FINAL REPORT

ARIZONA CANAL DIVERSION CHANNEL AESTHETICS COMMITTEE

MAY 5, 1989

RE: Transmittal of ACDC Aesthetics Committee Final Report
for Review and Comment

Figure 17. REACH 4: EAST BOUNDARY OF REACH 3/
DREAMY DRAW TO STATE/14TH STREET

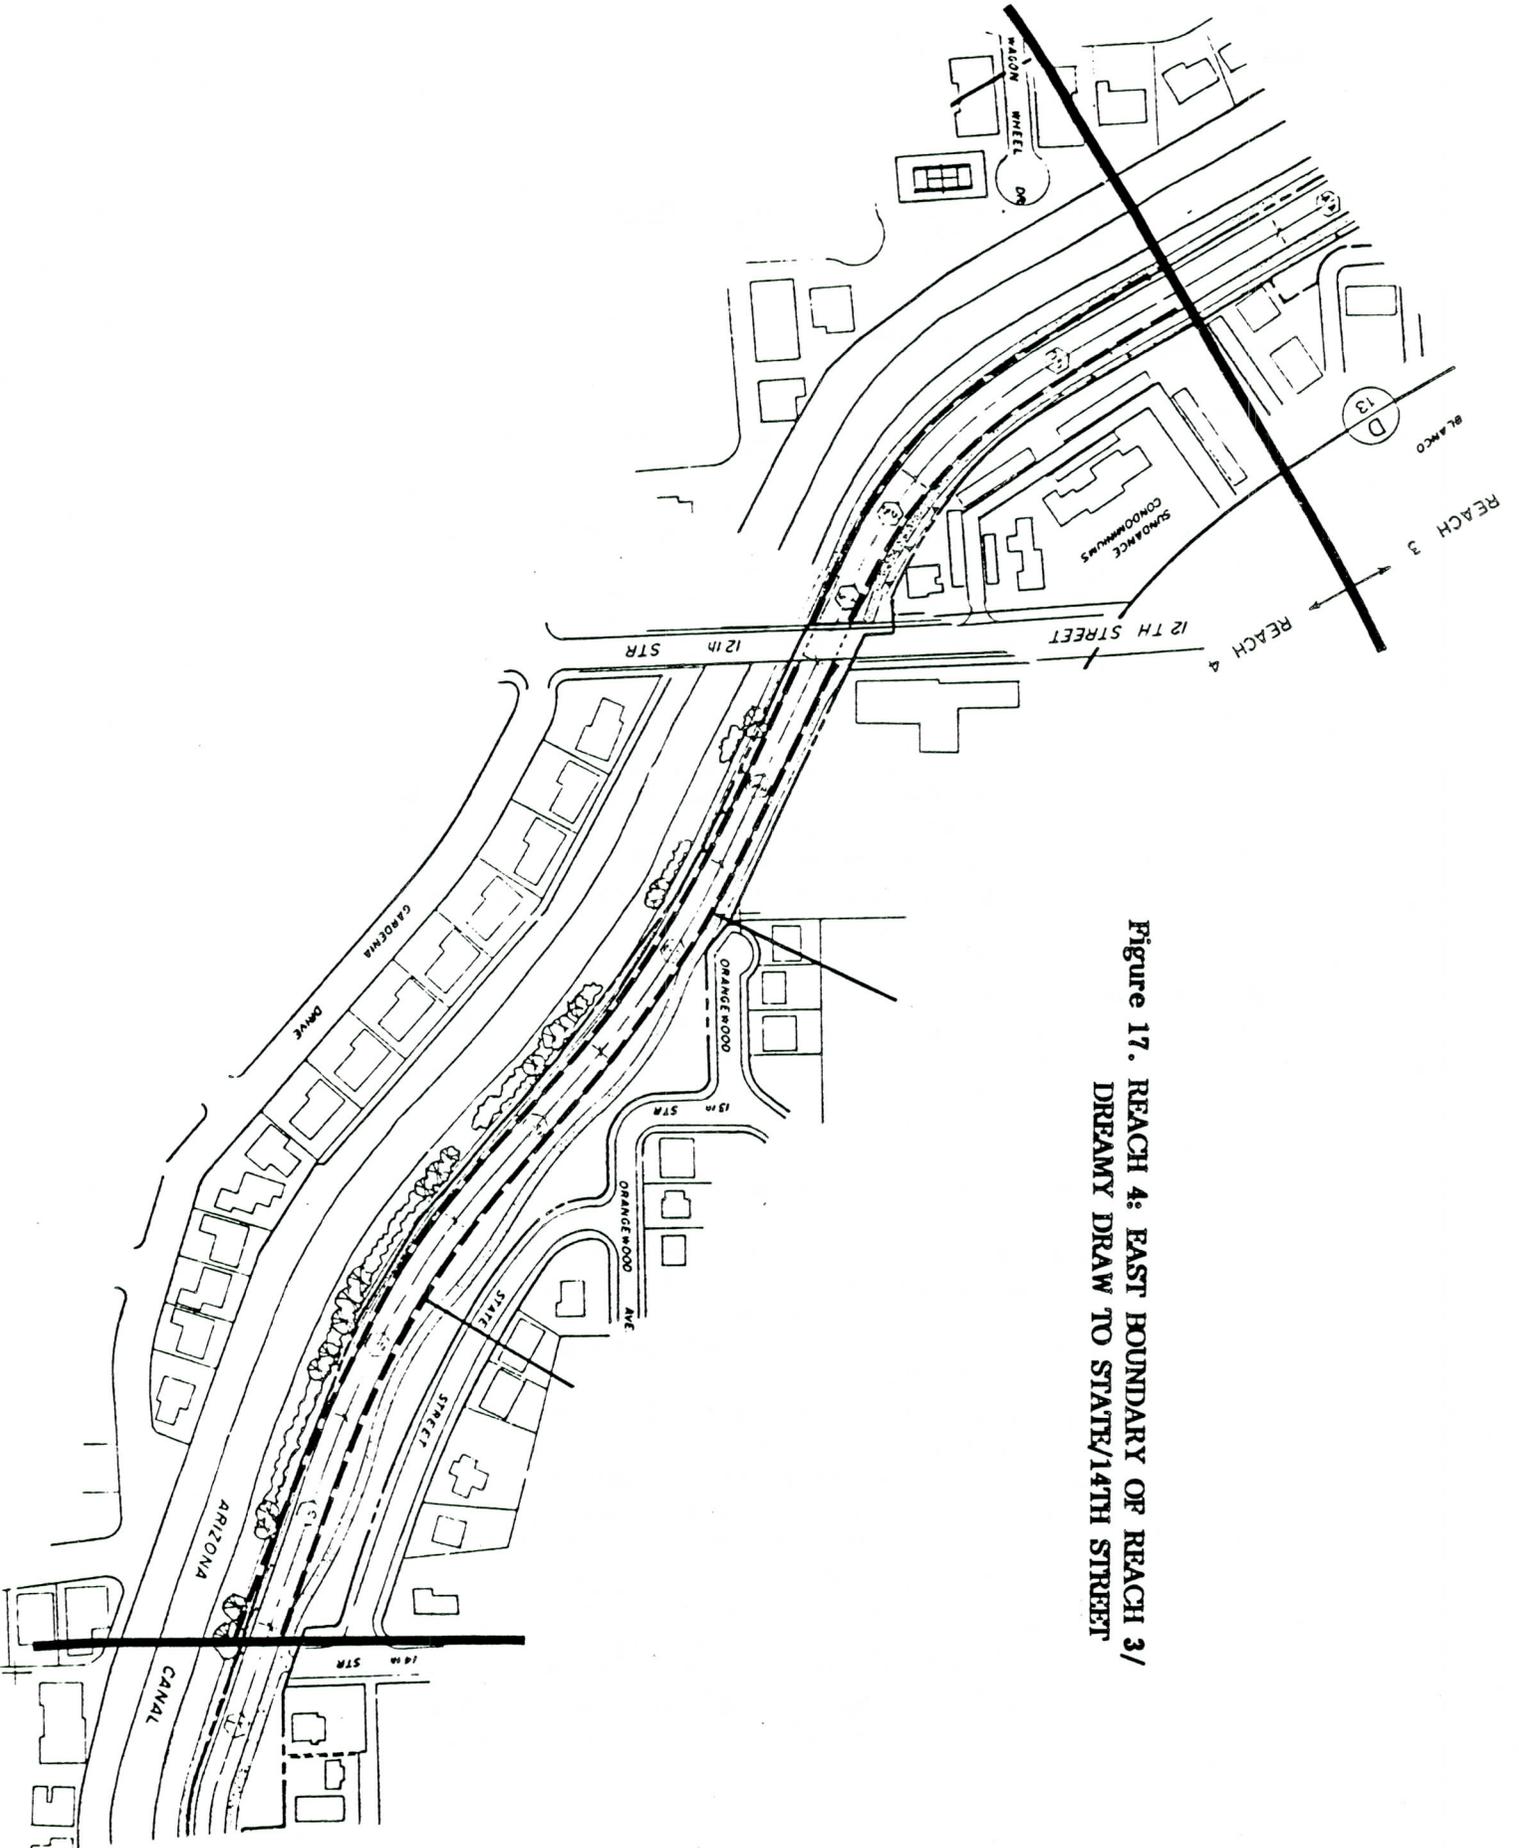
1. Design landscaping in this subreach with upgraded plant sizes, spacing to provide screening where needed and use of plant materials consistent with neighborhood character. Intensify landscape treatments at 12th Street, where homes face the ACDC and where multi-story homes are located adjacent to the Channel.
2. Explore possibility of planning special landscaping, recreation or public art treatments reflecting neighborhood character at 12th Street and along Orangewood/State Street/14th Street.
3. Where mesquite and other mature trees are impacted by construction of the ACDC, it is strongly recommended that they be preserved in place. If this cannot be done, the trees should be relocated within the same general area. An inventory should be prepared identifying and locating all significant trees in the ACDC corridor for this subreach.

4. Increase the amount of landscaping provided on the south bank of the ACDC. Explore possible realignment of the trail to provide additional area for landscaping.
5. Take steps to protect the privacy of homes along the ACDC and to assure a high level of security (see also recommendations for Subreach 7).
6. Design the ACDC landscaping to include "green" (but water conservative) ground covers and a mix of shrubs and trees that reflect the character of existing landscaping in adjoining neighborhoods.

Figure 18. REACH 4: STATE/14TH STREET TO 19TH STREET/SQUAW PEAK PARKWAY (SUBREACH 5)

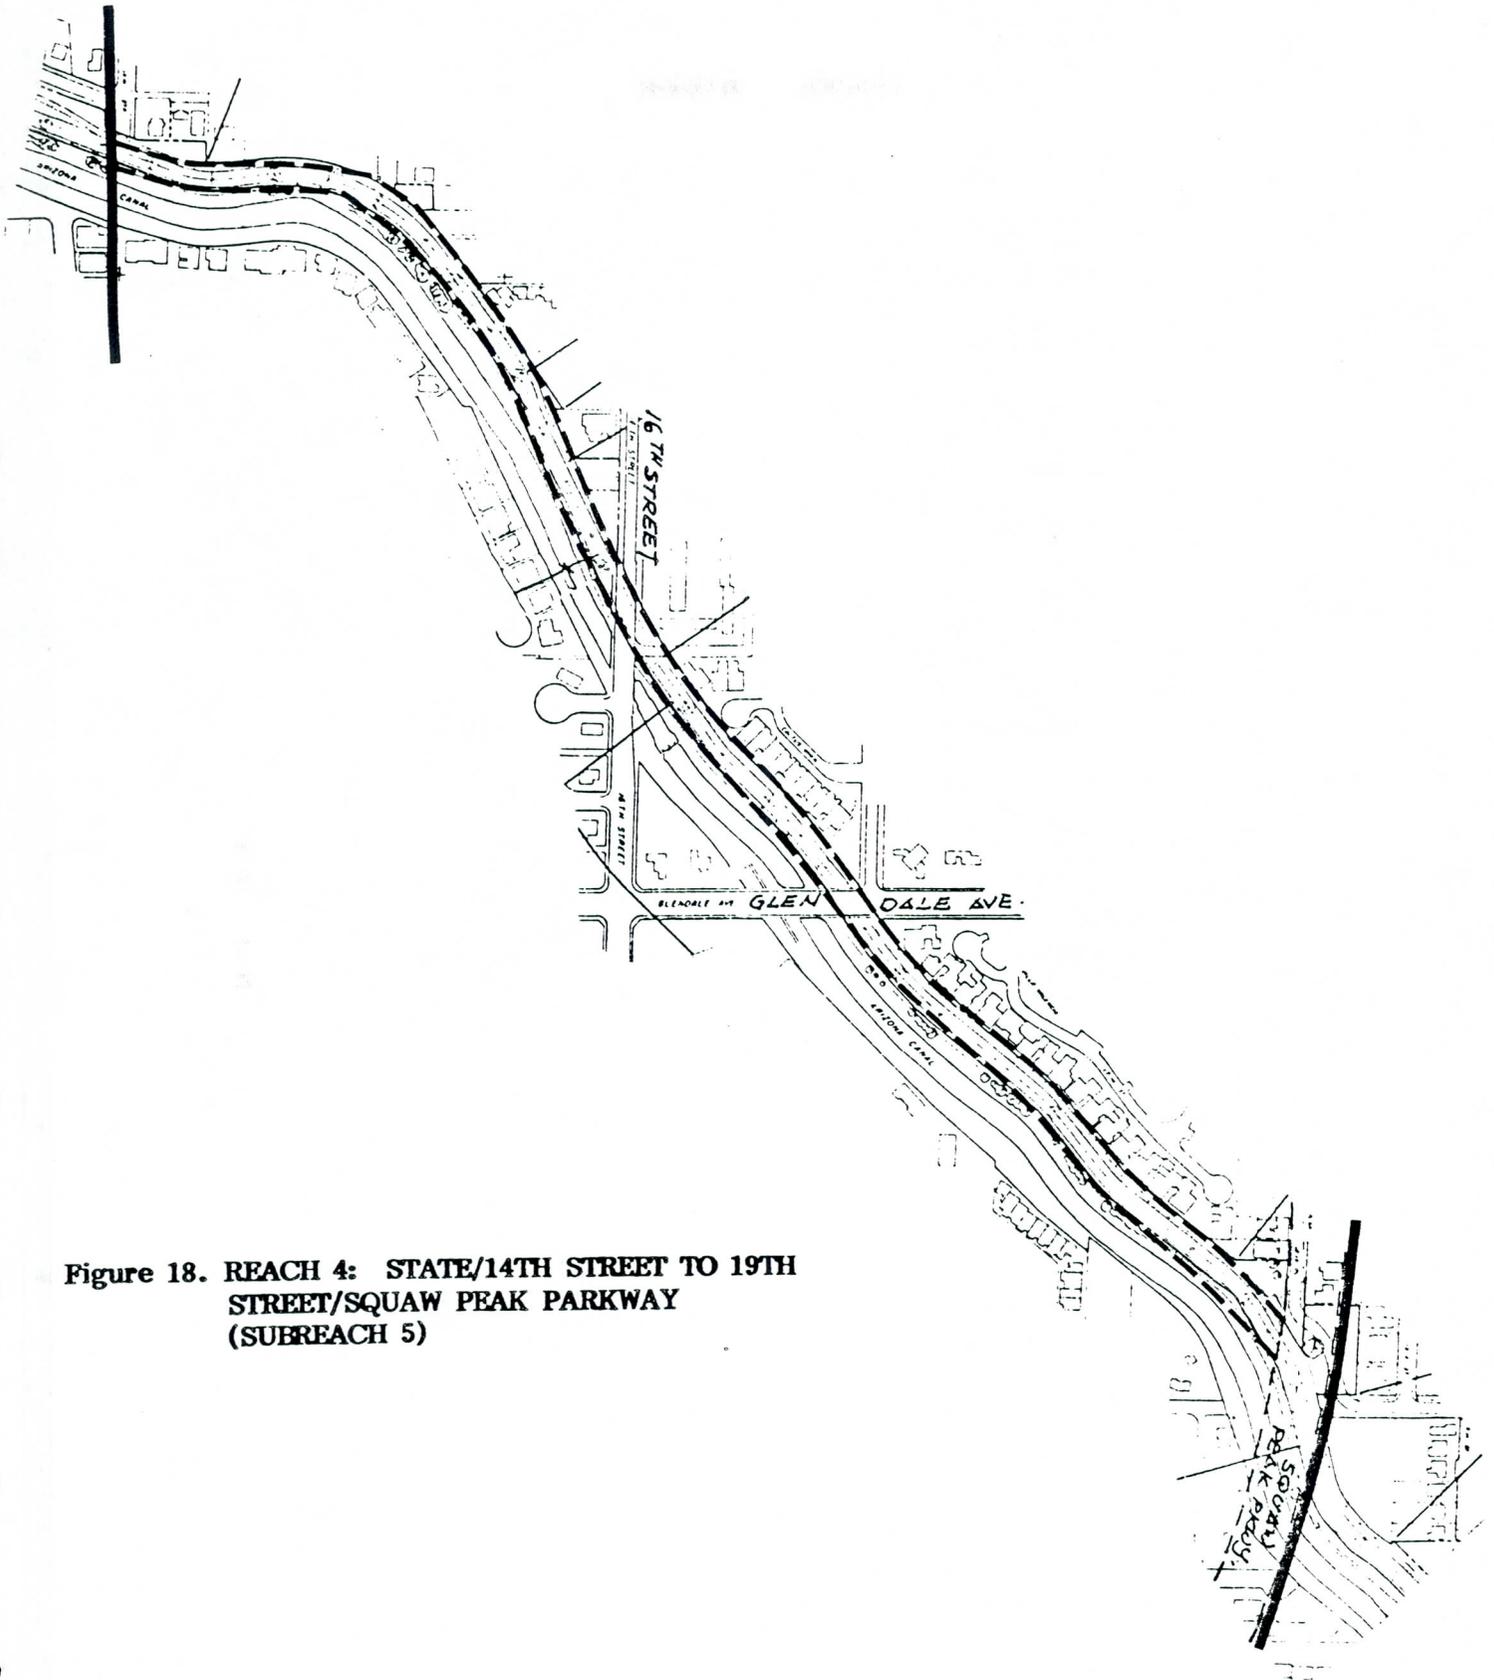
1. Design landscaping to include plant materials and general character representative of those found in adjoining neighborhoods.
2. Increase the size and number of plant materials to create a level of landscaping quality appropriate to the high visibility of this area, to the ACDC's exposure from adjacent homes and to trail users.
3. Prepare and implement design plans for special aesthetic treatment of the 16th Street/Glendale/ACDC triangle to create, for example, a gateway, theme landscaping, public art site, trail rest area or similar amenity.
4. Plan for additional landscaping on south banks of the ACDC and Arizona canal in the vicinity of the 16th Street/Glendale intersection.
5. Where mesquite and other mature trees are impacted by

construction of the ACDC, it is strongly recommended that they be preserved in place. If this cannot be done, the trees should be relocated within the same general area or replaced with trees of the same variety and as close to the original size as possible. An inventory should be prepared identifying and locating all significant trees in the ACDC corridor for this subreach.

Figure 19. REACH 4: 19TH STREET/SQUAW PEAK
PARKWAY TO 24TH STREET (SUBREACH 4)

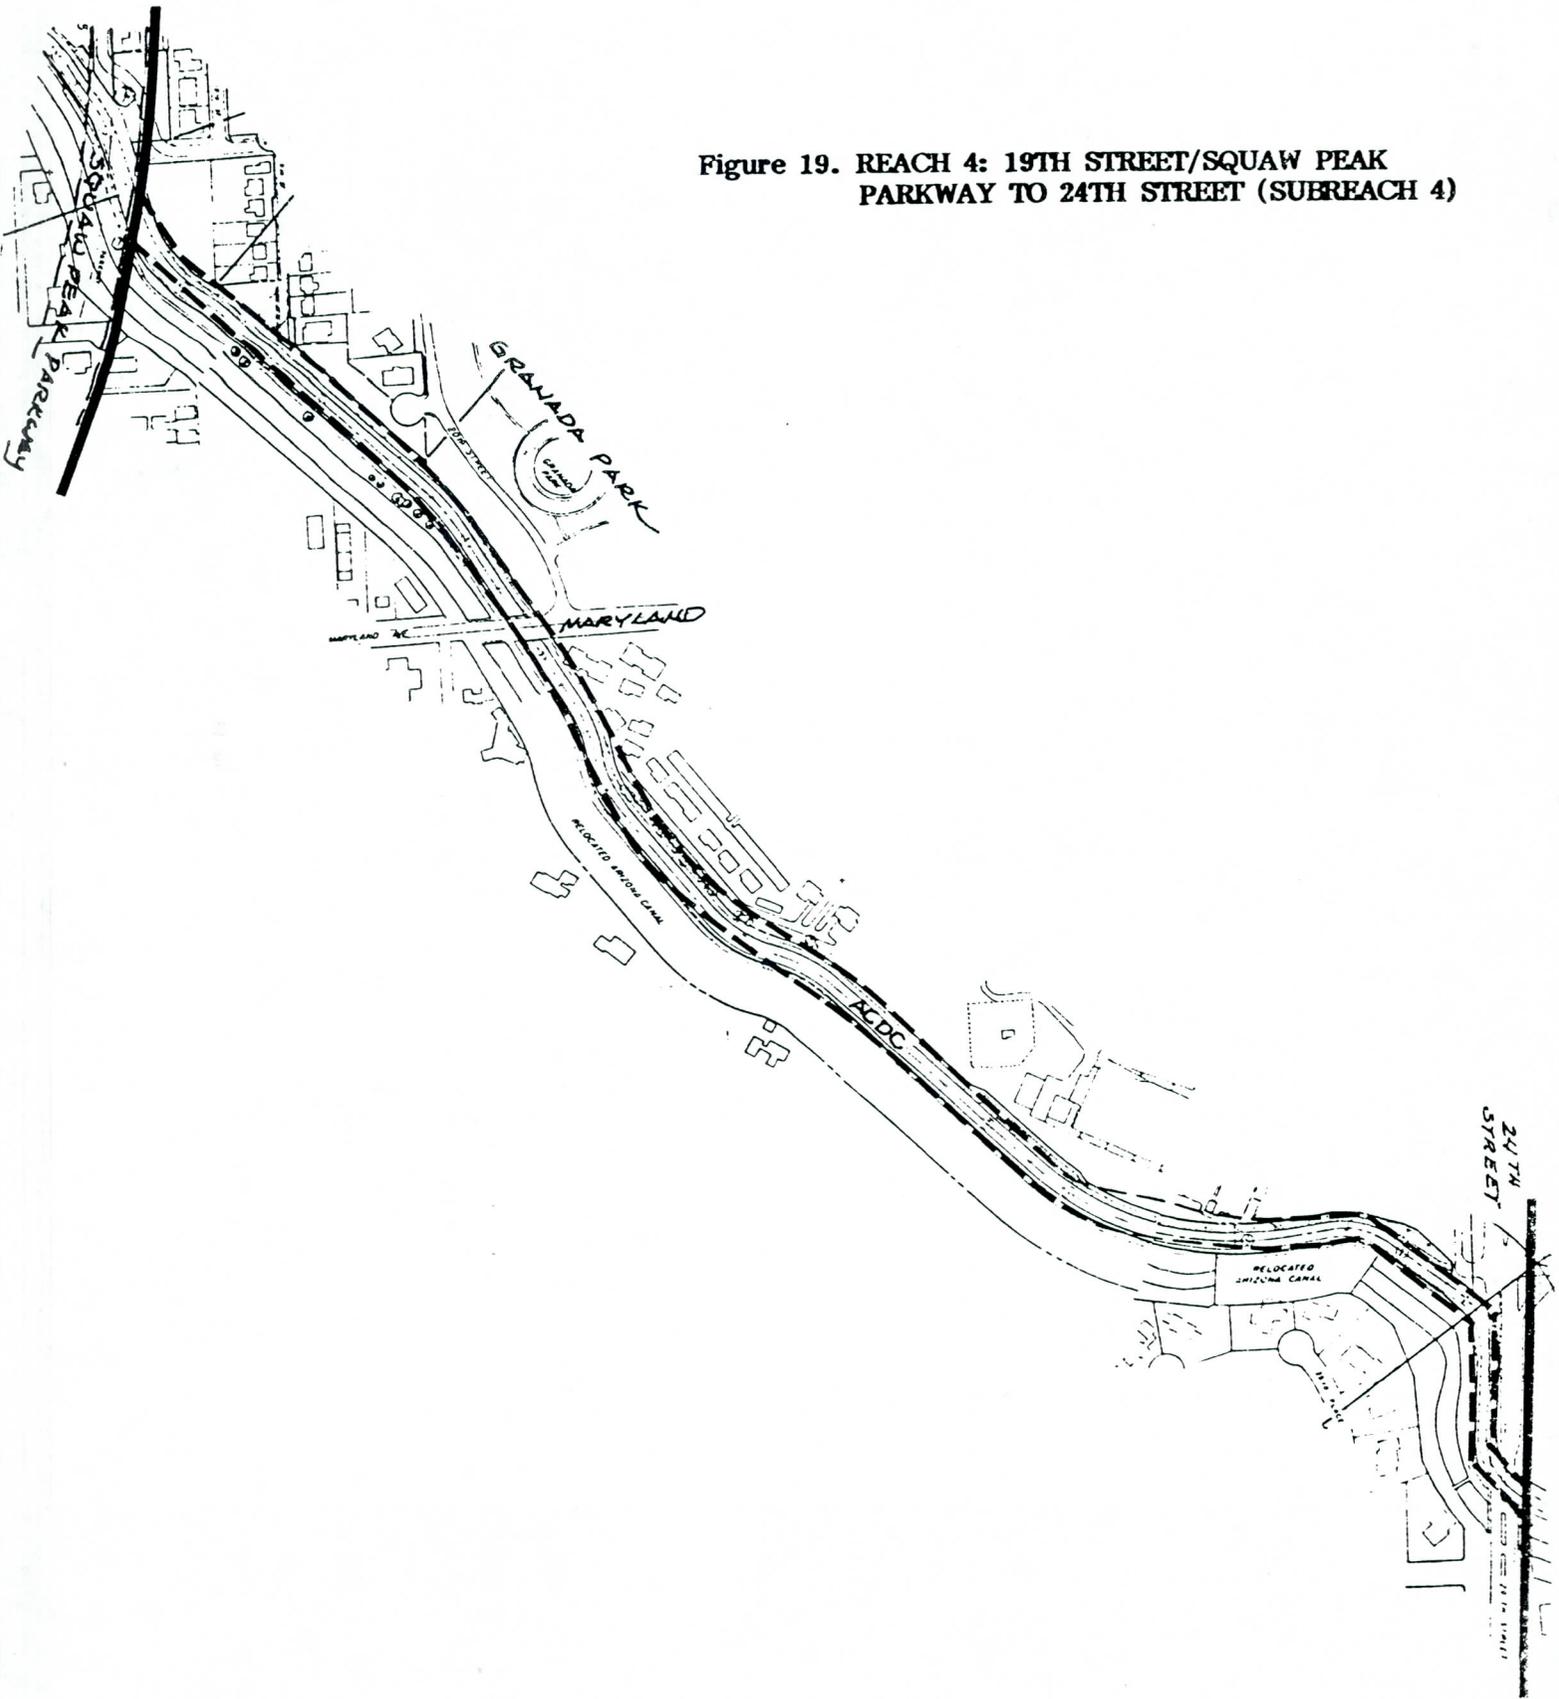
4. Work with Salt River Project to find a way to increase landscaping on the south bank of the ACDC, between the trail and the Channel.
5. Where mesquite and other mature trees are impacted by construction of the ACDC, it is strongly recommended that they be preserved in place. If this cannot be done, the trees should be relocated within the same general area or replaced with trees of the same variety and as close to the original size as possible. An inventory should be prepared identifying and locating all significant trees in the ACDC corridor for this subreach.

plans for this part of the ACDC to work with neighbors to provide buffers, ensuring private and security for home owners and other residents.

Figure 21. REACH 4: STANFORD DRIVE AREA
(SUBREACH 2)

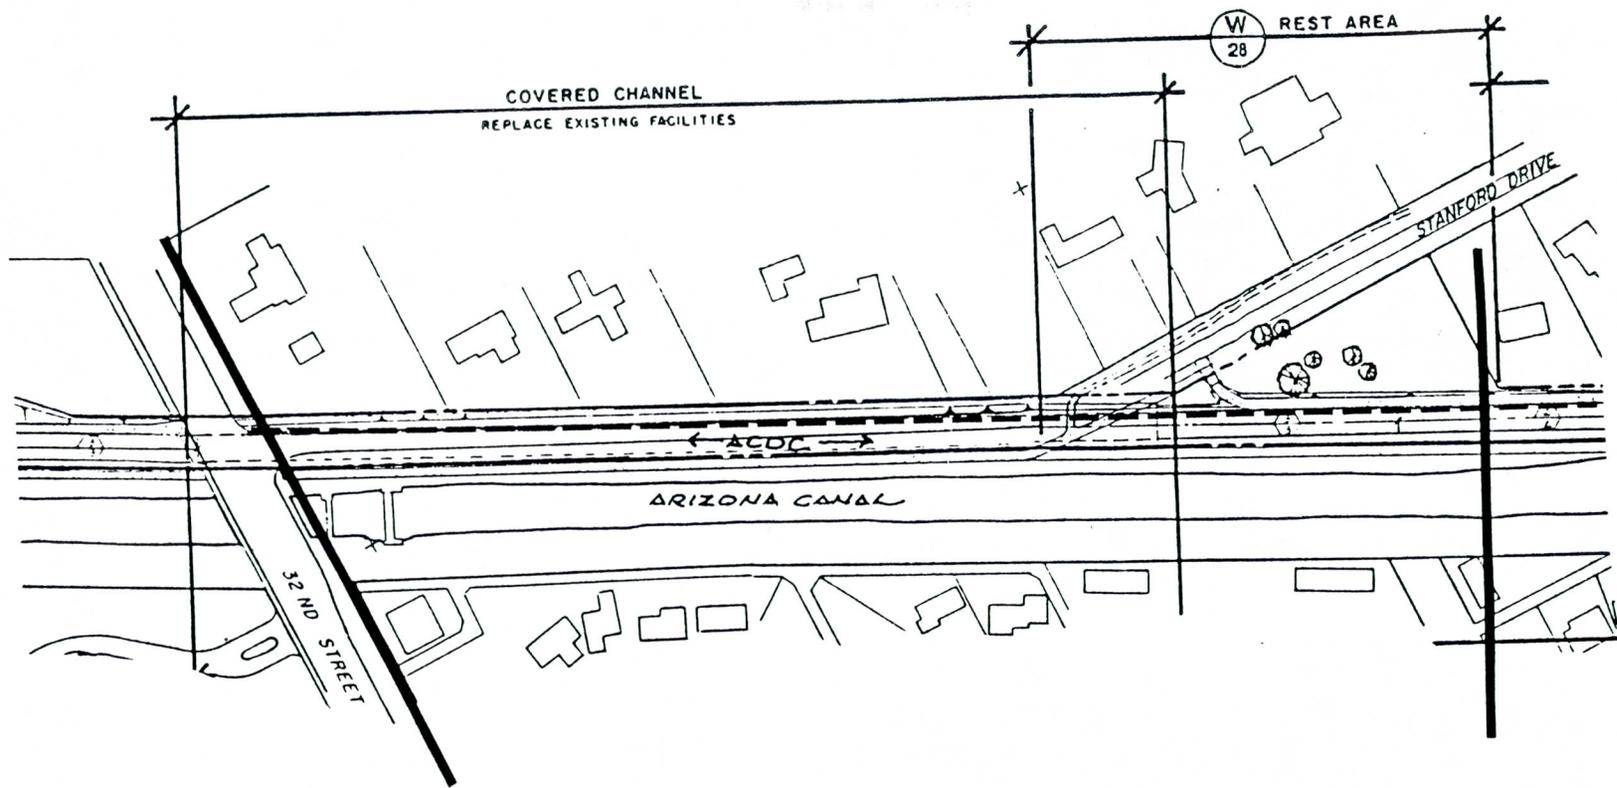
1. Provide a staging area in or near this subreach that will accommodate parking for trail users as well as shade, water and other amenities. If necessary, provide a trail bridge for access to the staging area.
2. Design and construct trails to standards referenced previously in this report.
